Addendum 85 – Regulation No. 86

Revision 2 – Amendment 1

01 series of amendments – Date of entry into force: 22 June 2017

Uniform provisions concerning the approval of agricultural or forestry vehicles with regard to the installation of lighting and light-signalling devices

Direction-indicator lamps - Geometric visibility

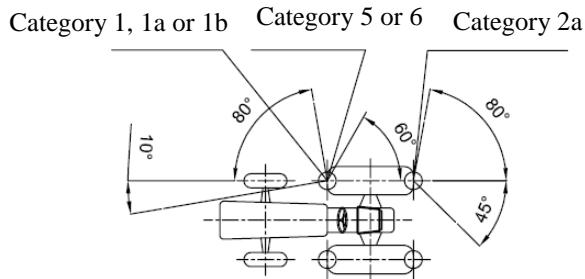
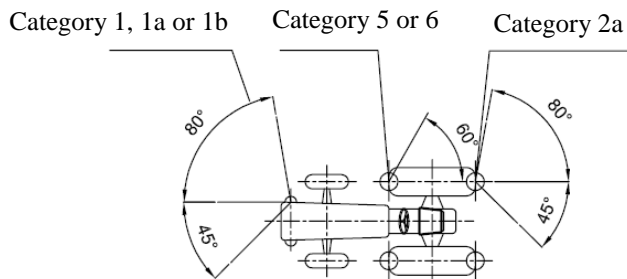
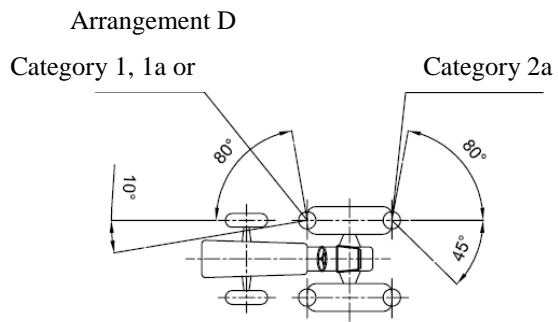
Annex 5, amend to read:

For all the arrangements the following applies:

The value 10° given for the inward angle of visibility of the front indicator may be reduced to 3° for vehicles with an overall width not exceeding 1,400 mm.

For rear direction indicators, the horizontal inward angle may be reduced to 30° if the shape of the bodywork makes it impossible to reach 45°."

Figure 1.

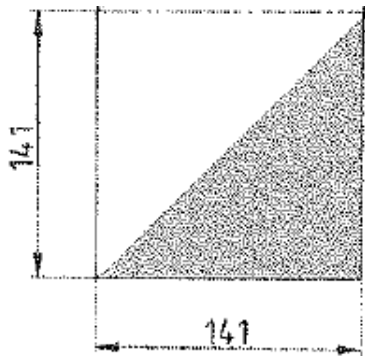
1. Dimensions, arrangement, number and minimum reflecting surface
- 1.1. Signalling panels and signalling foils shall have the following dimensions:

Figure 2.

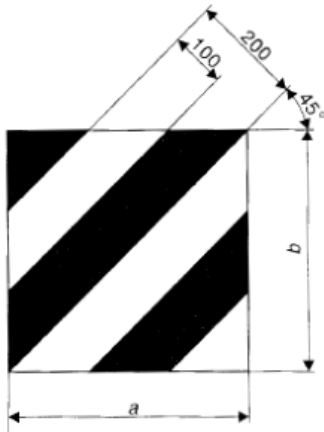
Deviations from the specified formats are permitted, provided that:

- (a) The visible surface of each panel or foil shall be at least equal to 4 basic standard areas and
- (b) Each panel or foil shall comprise at least 3 entire basic standard areas.

If the structure, design or the operational use of the vehicle makes it impossible to comply with such a requirement, each panel or foil may be split into 2 parts as long as each part comprises at least 2 entire basic standard areas.
